Environmental Assessment

Laguna Water System Improvement

Descanso Ranger District, Cleveland National Forest
San Diego County, California

Figure 2. Map of Proposed New Singletrack Trail

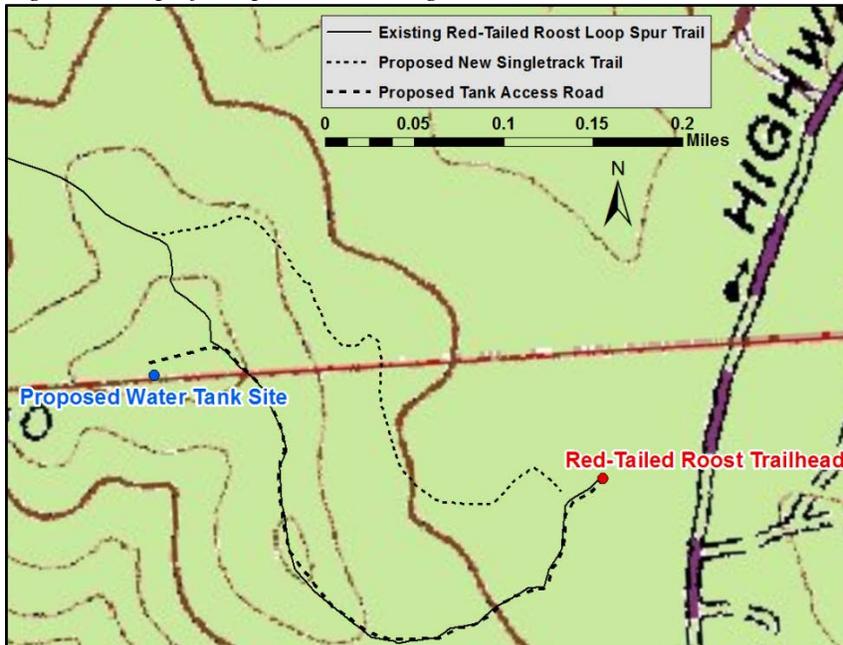
Comment #3: Support improvements to the Laguna Recreation Area but cannot support destruction of the Red Tail Roost Trail without providing a new sustainable contour trail in its place. There are too few trails available as it is. A fire road is not a trail and thus does not provide the same outdoor experience.

In response to concerns raised by the public during the comment period on the Draft EA, a new singletrack trail would be constructed to avoid the trail segment that would be transformed into a tank access road prior to other project construction. The trail would begin at the Red-Tailed Roost Volunteer Headquarters and connect to the existing Red-Tailed Roost Loop Spur Trail just beyond the site of the proposed water tank (Figure 2).

Response: The construction of a new singletrack trail segment has been added to the proposed action (p. 3) to replace the segment of the Red-Tailed Roost Loop Spur Trail that would become the tank access road.
